Appendix H. Response to Comments Exhibits – City of Signal Hill

TECHNICAL ADVISORY COMMITTEE PROJECT REVIEW REQUIREMENTS BY DEPARTMENT OF PUBLIC WORKS

Subject: 2851 ORANGE AVENUE – Case No. 1802-22

City of Signal Hill
Comments
4/7/20

Refined Conceptual Street Cross Section

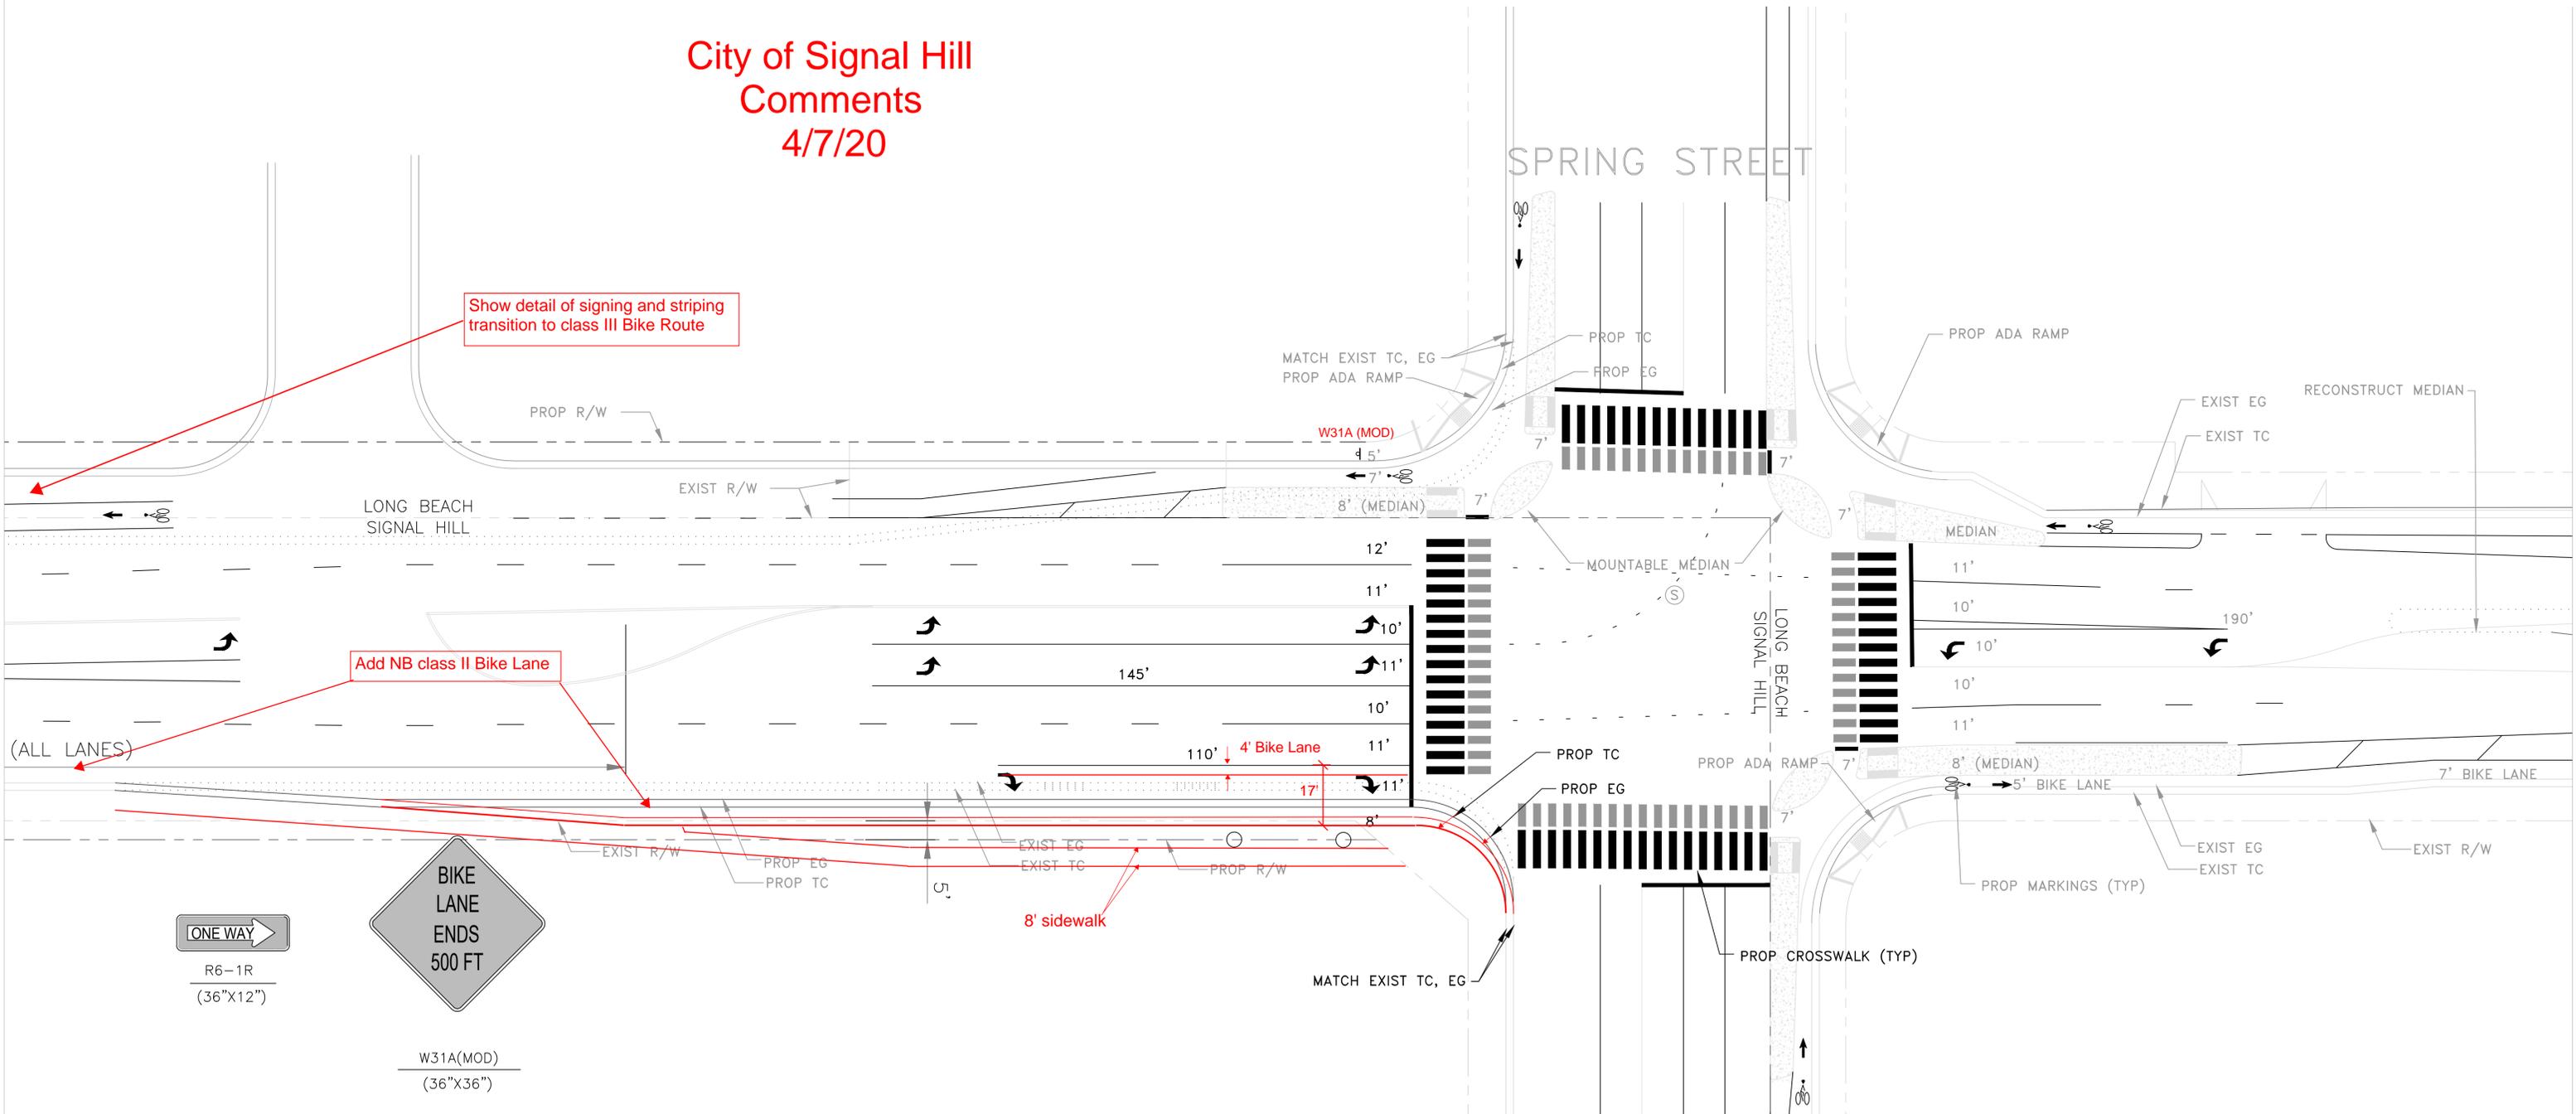
Attached are our comments regarding the latest proposal for the street configuration within City of Signal Hill R/W. We wish to widen the NB Orange right turn to 17' to accommodate a bike lane. The sidewalk can be routed on the other side of the SCE steel poles. We've discussed with SHPI and they support this change. **With these changes, the City is ready to support the proposed plan.**
